STANDARD DEPARTURE CHART - INSTRUMENT

RJNH / HAMAMATSU

Civil Aviation Bureau, Japan (EFF:21 APR 2022)

KOWA SIX DEPARTURE

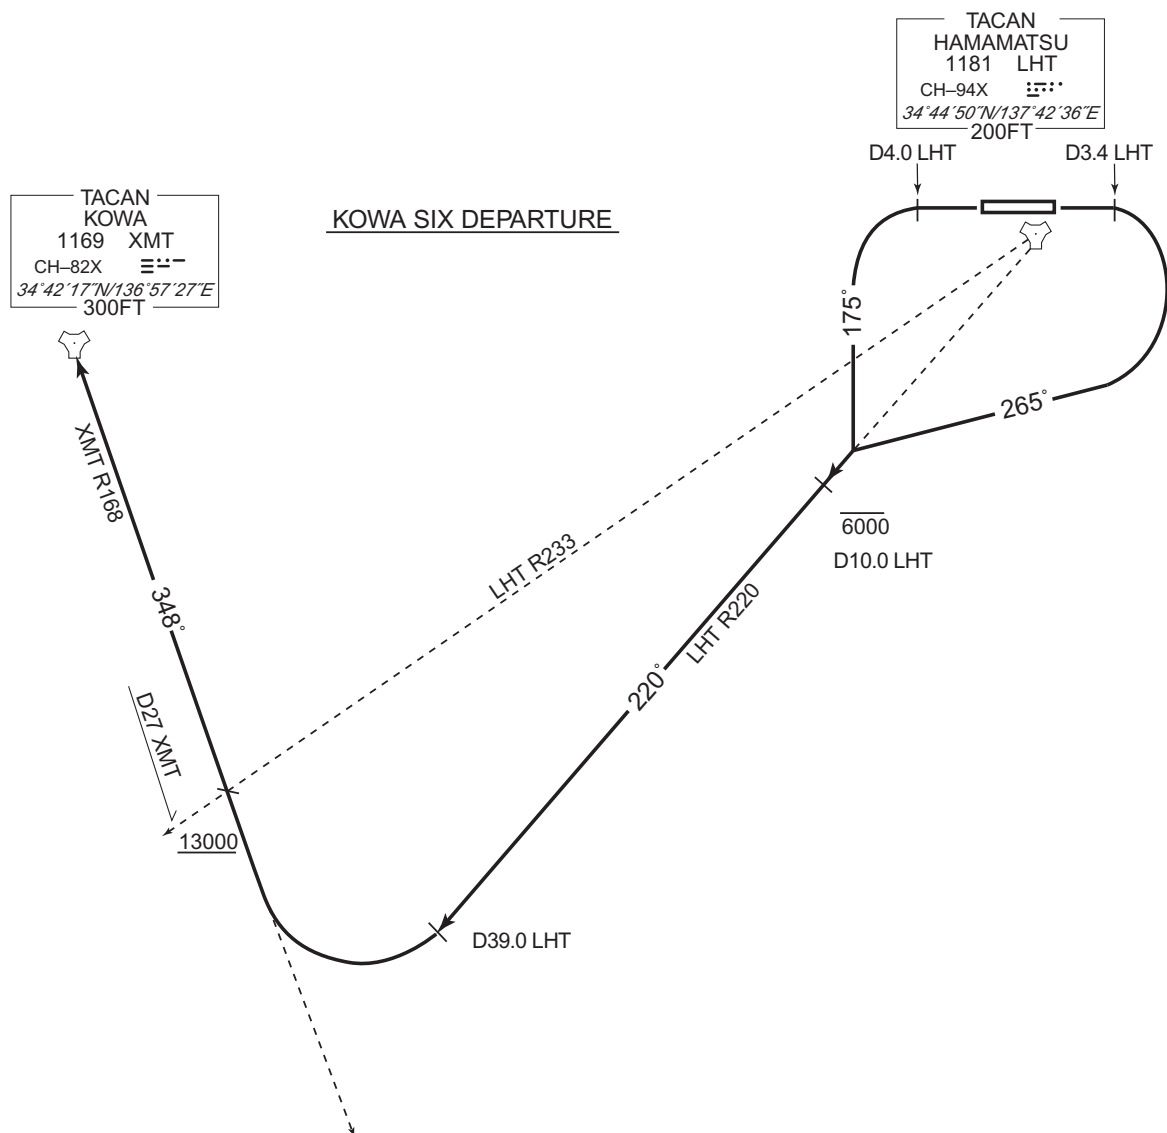
CHANGE : PROC renamed. PROC course. Note deleted.

ATSUMI FIVE DEPARTURE

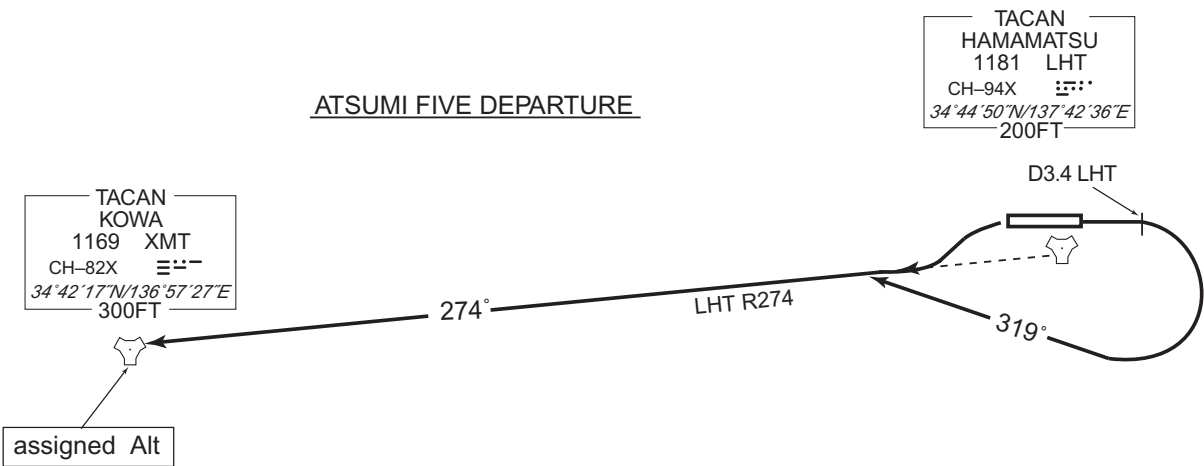
CHANGE : PROC renamed. PROC course. Note deleted.

HAMAMATSU REVERSAL THREE DEPARTURE

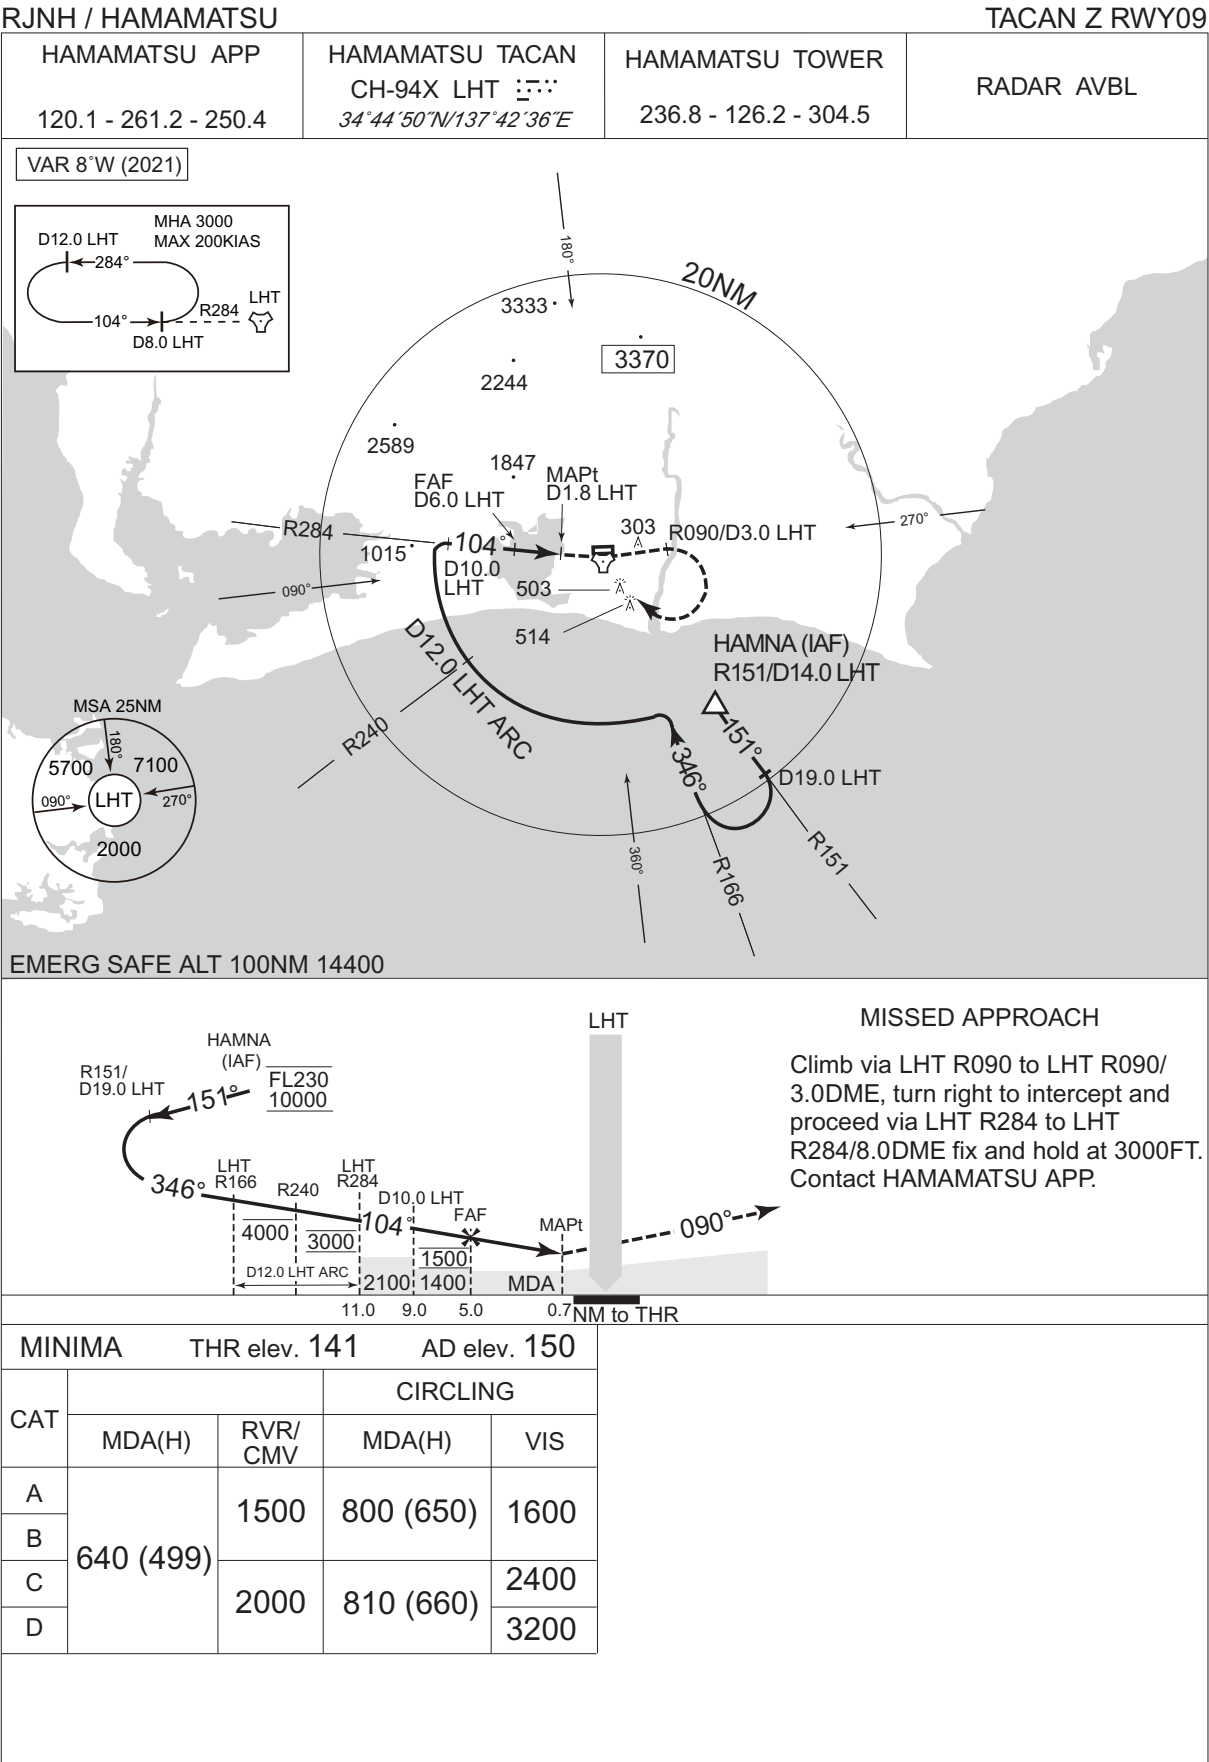
CHANGE : PROC renamed. PROC course. Note deleted.

TACAN Y RWY09

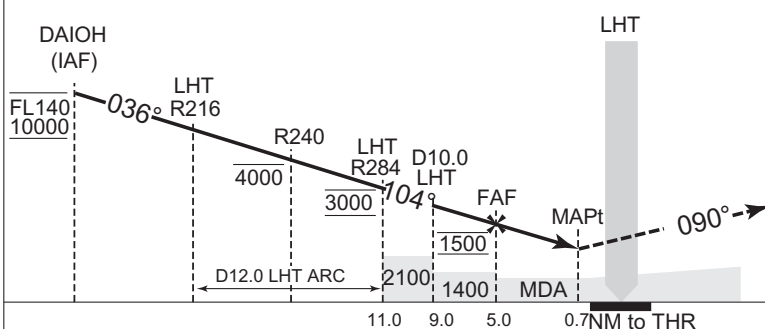
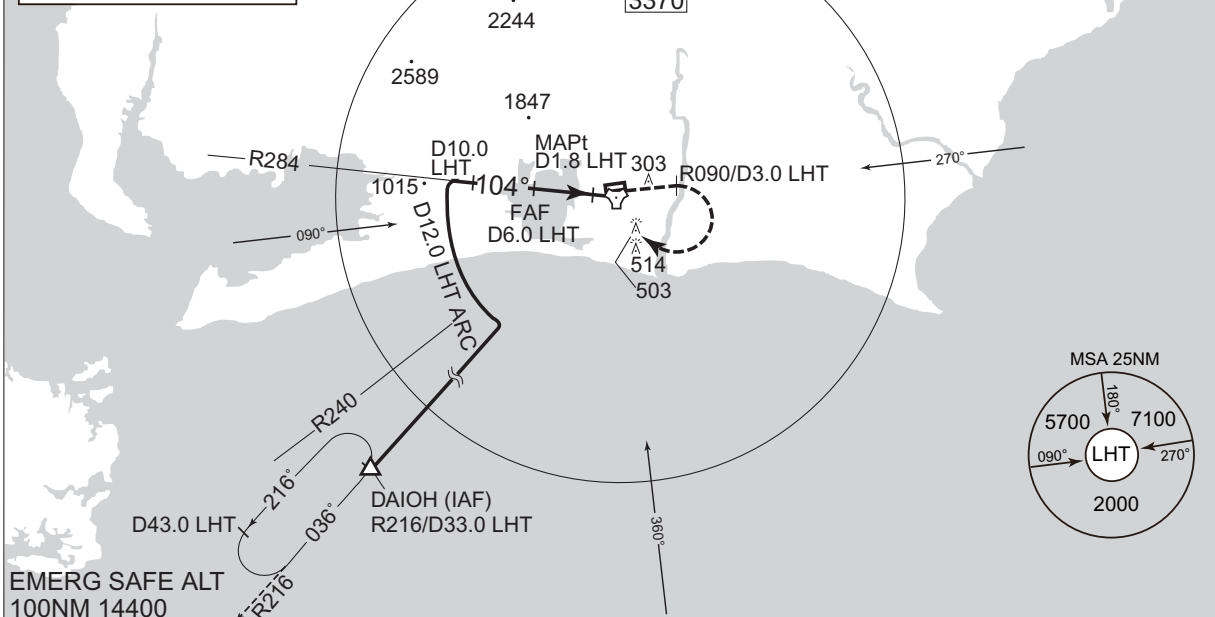
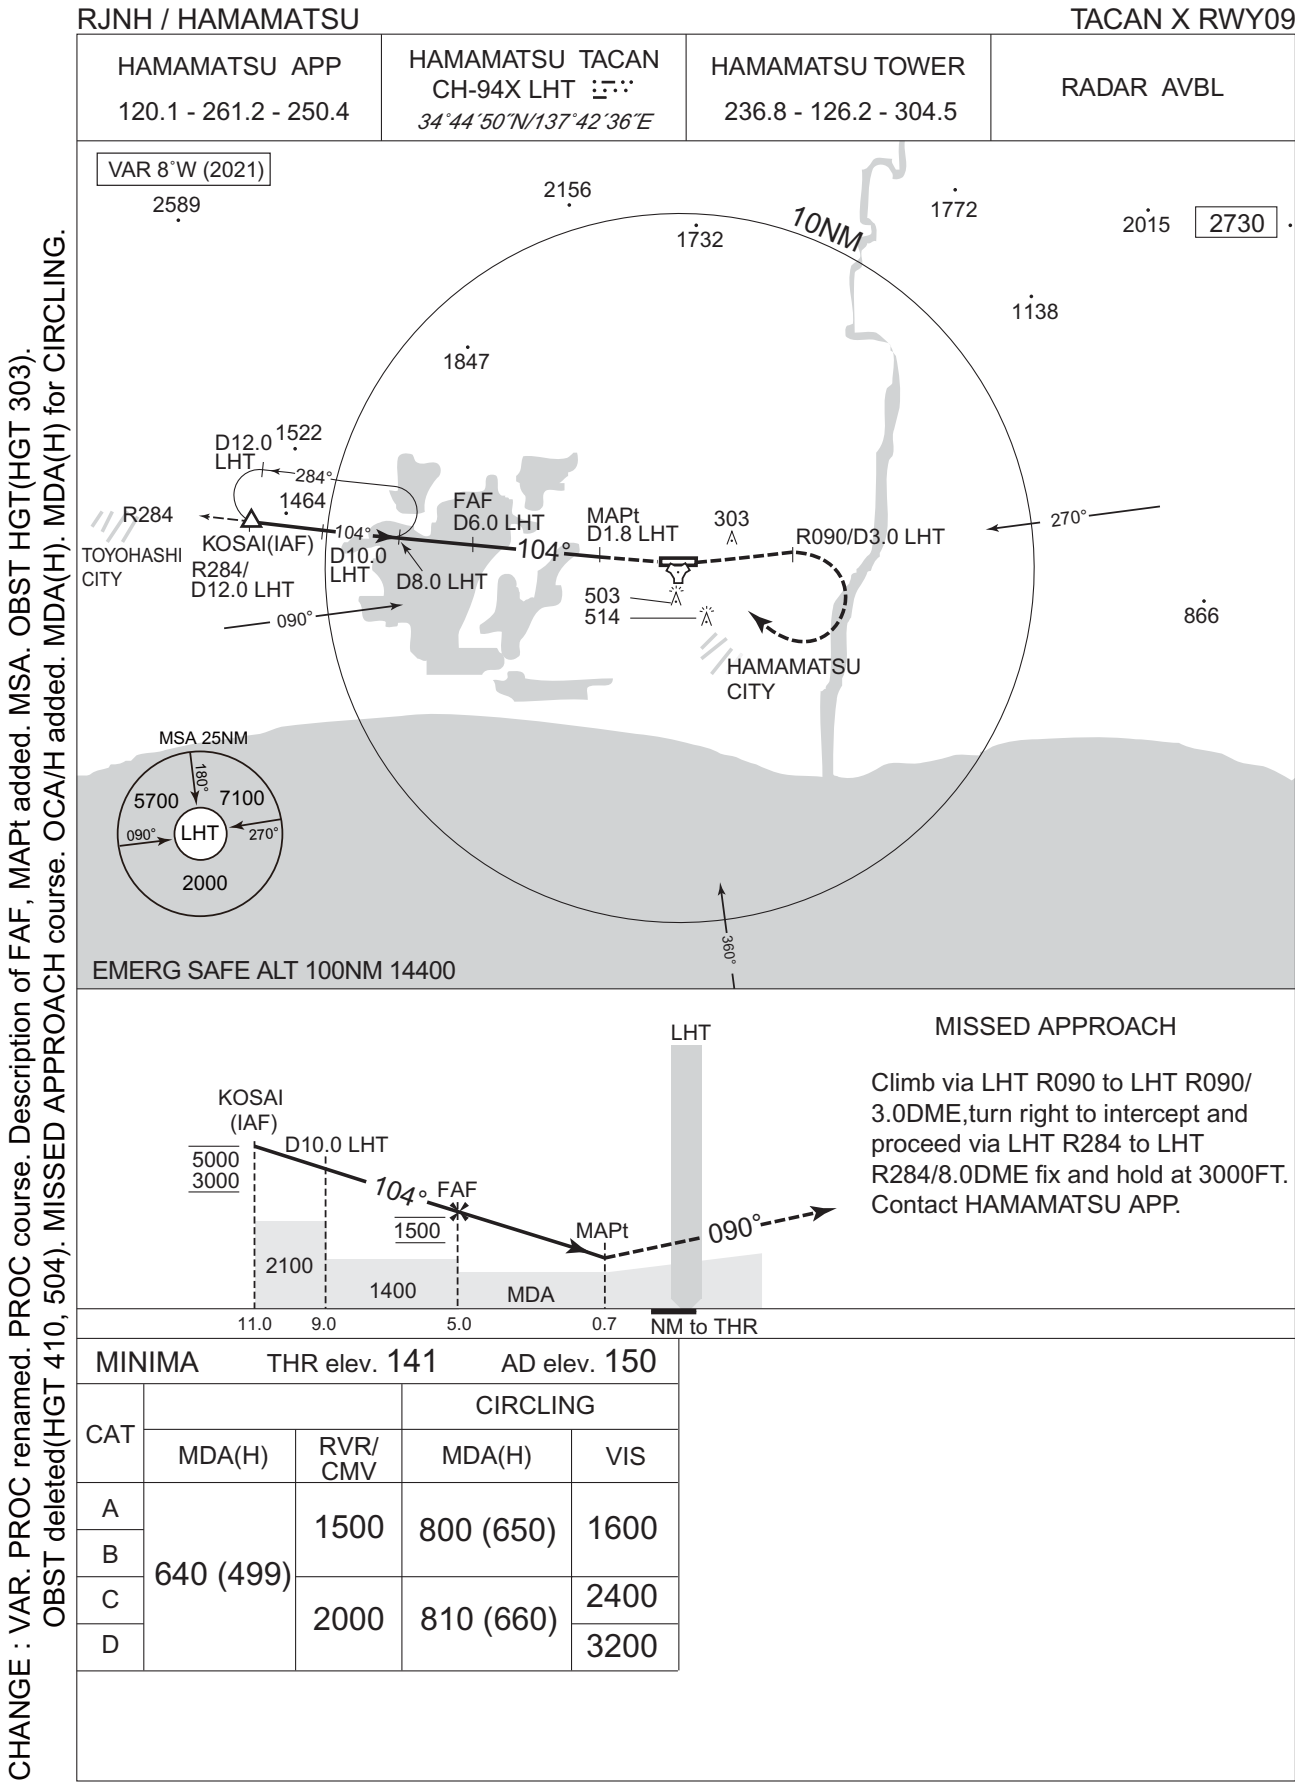
CHANGE : VAR. PROC renamed. PROC course. Description of FAF, MAPt added. OBST added(HGT 303).
OBST deleted(HGT 410, 504). MISSED APPROACH course. ALT restriction(DAIOH). OCA/H added. MDA(H) for CIRCLING.
